# Submission in respect of the proposed Snowy 2.0 Segment Factory

by Robert Jenkins, Cooma  
5 November 2019

Fig 3 - Weekday peak hour intersection traffic volumes (Table 3-3) from Snowy 2.0 Main Works Traffic and Transport Assessment

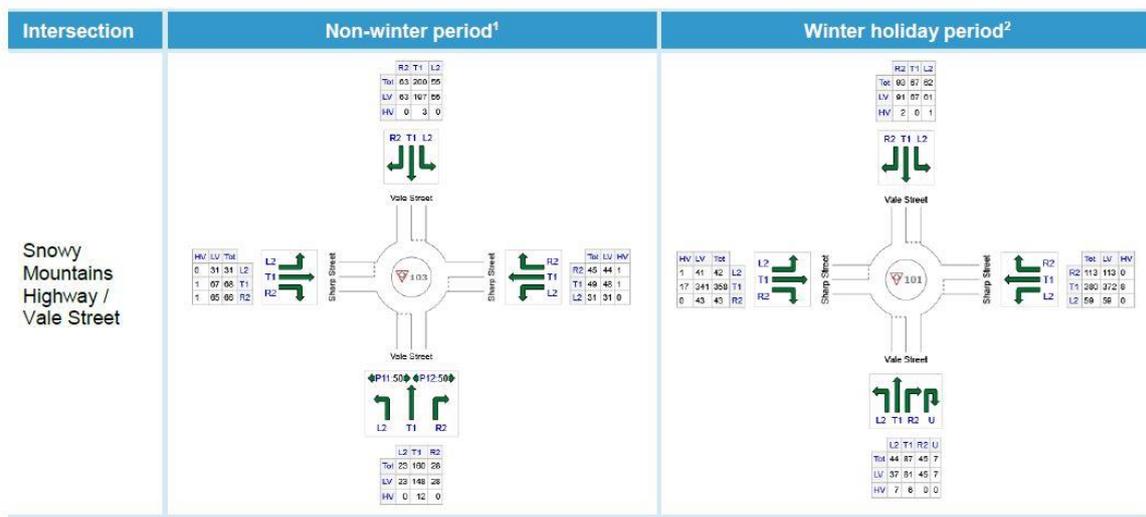
Figure 3 is an excerpt from Table 3-3 of the Snowy 2.0 Main Works Traffic and Transport Assessment and shows the peak hour traffic at the Sharp Street and Vale Street intersection. It demonstrates that almost all traffic is light vehicle. And taking account of the fact that HV vehicles include minibuses, light trucks (delivery vans) and coach buses, it is most probable that what HV vehicles were recorded did not include a single heavy truck.

The actual volume of heavy vehicle traffic on Sharp Street is light. Figure 3, peak hour traffic data at the Sharp Street/Vale Street intersection from the traffic assessment, shows just four heavy vehicles on Sharp Street across a whole hour. This is realistic.

Fig 6 – Baseline average daily traffic for Cooma area from Annexure A Existing traffic data of the Snowy 2.0 Main Works Traffic and Transport Assessment

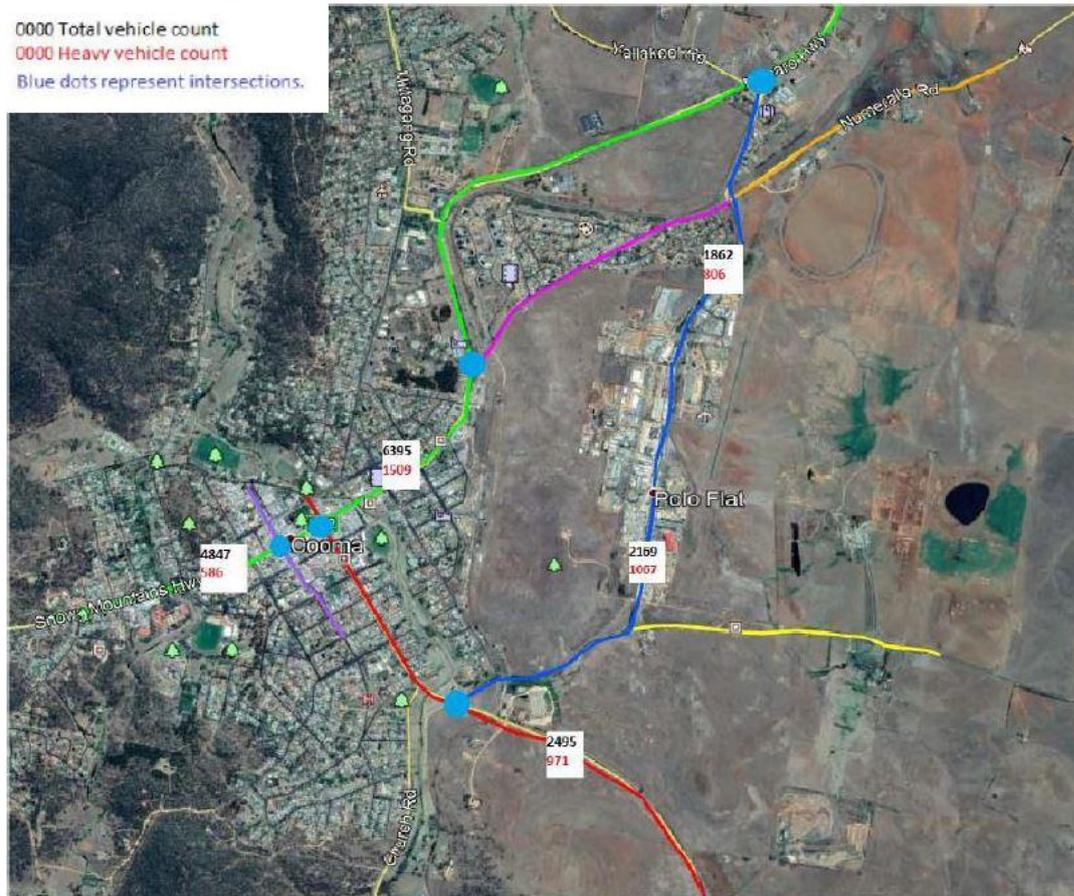
The EIS baseline average daily traffic volumes are clearly inconsistent with the volume measured at the RMS permanent counter. In particular, the EIS shows 1509 heavy vehicles per day on Sharp Street on the north eastern approach into Cooma and 586 heavy vehicles per day on the south western approach to Cooma. Assuming the majority of 1509 vehicles travel across 10 hours of the day, the hourly volume of heavy vehicles on Sharp Street is 150, or a heavy vehicle less than every 30 seconds across a whole day. This is not correct and calls into question conclusions reached in the traffic assessment.

Fig 7 – RMS average daily traffic count on Monaro Highway, 400m east of Polo Flat Road

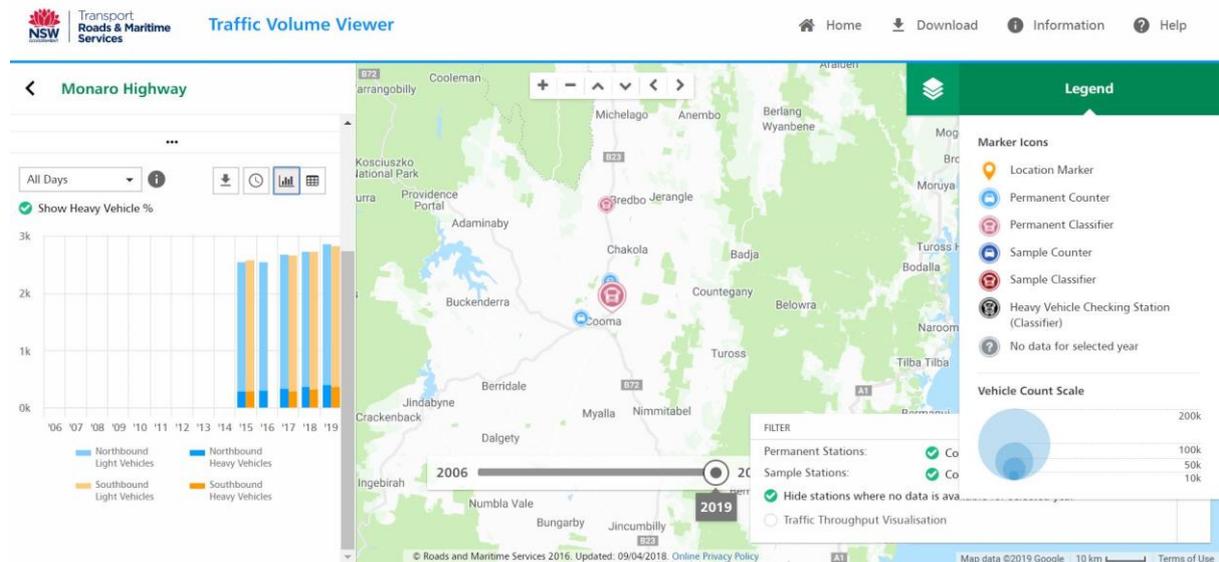
The RMS average daily traffic count for 2019 is 5704 total vehicles which includes 790 heavy vehicles.

Fig 9 - Average Total Project Traffic from Annexure D Construction traffic volumes of the Snowy 2.0 Main Works Traffic and Transport Assessment

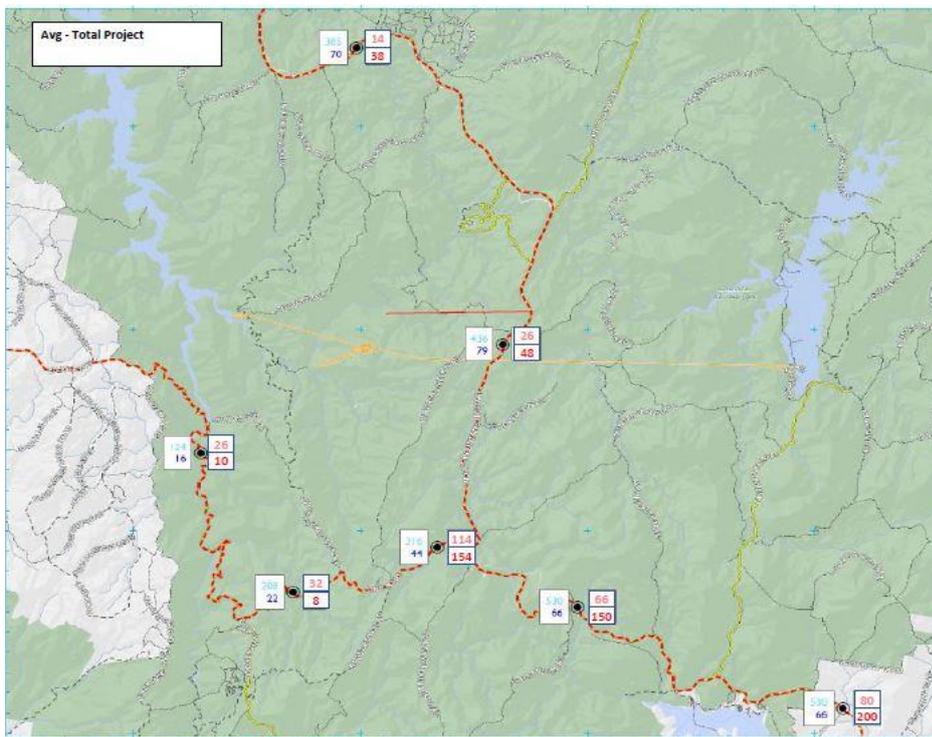
The impacts of project traffic are shown in Figures 9 and 10 which are excerpts from Annexure D Construction traffic volumes of the Snowy 2.0 Main Works Traffic and Transport Assessment.

near to impossible. Driver frustration will become a significant problem. Drivers will take serious risks to overtake.
